ADDENDUM NO. 1
WASTEWATER SYSTEM IMPROVEMENTS
CONTRACT I: PARNELL ROAD SEWER FORCE MAIN
EXTENSION AND VALVES FOR MASTER METERS
EL DORADO RURAL PUBLIC WATER AUTHORITY

15 July 2025
Corrected: 18 July

EL DORADO RURAL PUBLIC WATER AUTHORITY
PARNELL ROAD EXTENSION PLANS

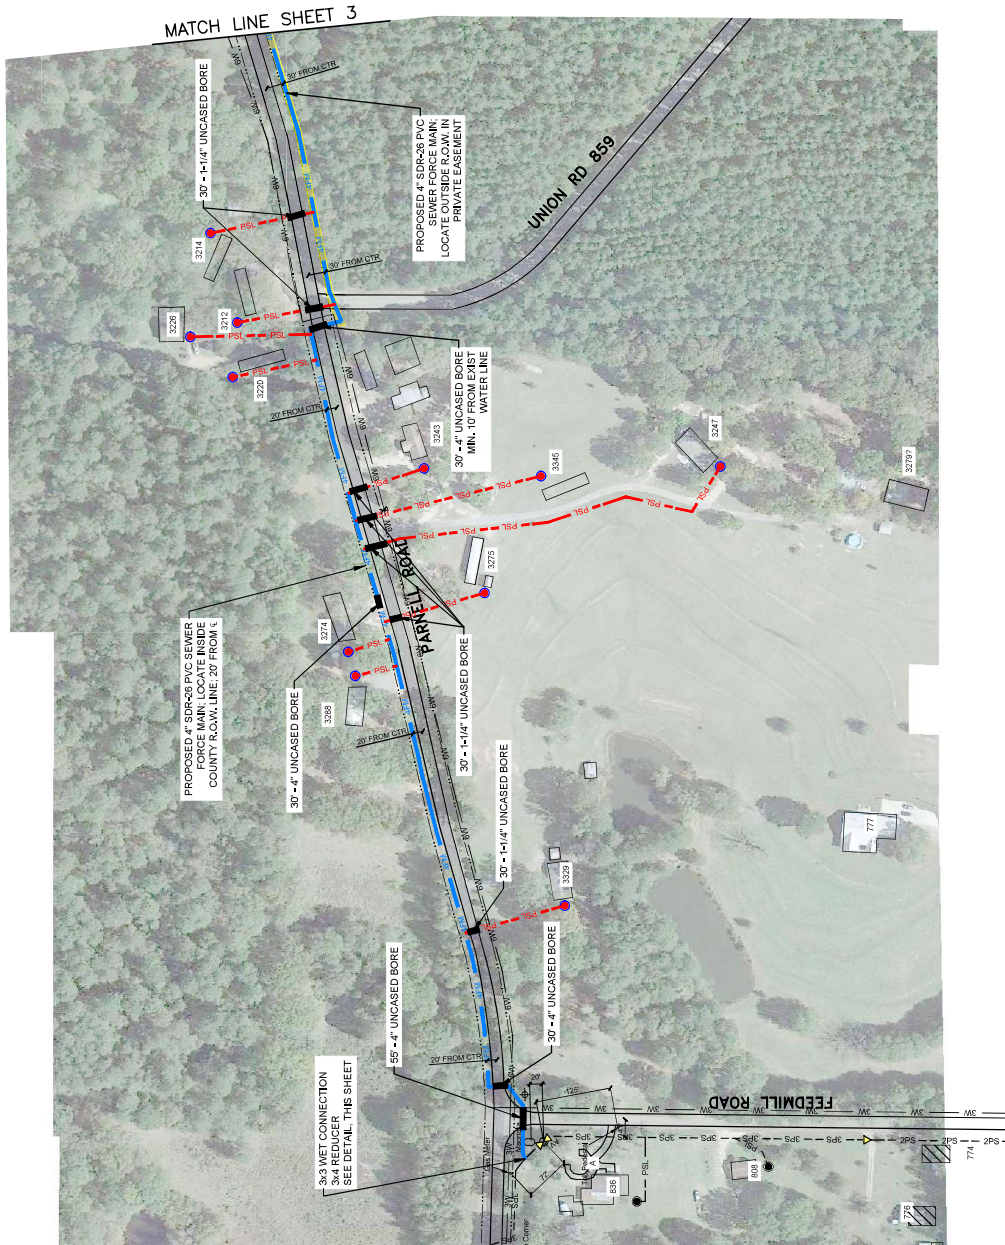
Replace Sheet 2 with the attached Sheet 2 (corrected identification of the existing air release valve).

NO.	DESCRIPTION	DATE	APP.	CHK.
1	ADDENDUM 1 - RISE DESS. OF EXIST VALVE	07-2025		
2	MOVE PORTION OF LINE TO PRIVATE EASEMENT	08-2025		
3	MOVE LINE INSIDE PRIVATE EASEMENT	09-2025		
4				
5				
6				
7				
8				
9				
10				
11				
12				
13				
14				
15				
16				
17				
18				
19				
20				
21				
22				
23				
24				
25				
26				
27				
28				
29				
30				
31				
32				
33				
34				
35				
36				
37				
38				
39				
40				
41				
42				
43				
44				
45				
46				
47				
48				
49				
50				
51				
52				
53				
54				
55				
56				
57				
58				
59				
60				
61				
62				
63				
64				
65				
66				
67				
68				
69				
70				
71				
72				
73				
74				
75				
76				
77				
78				
79				
80				
81				
82				
83				
84				
85				
86				
87				
88				
89				
90				
91				
92				
93				
94				
95				
96				
97				
98				
99				
100
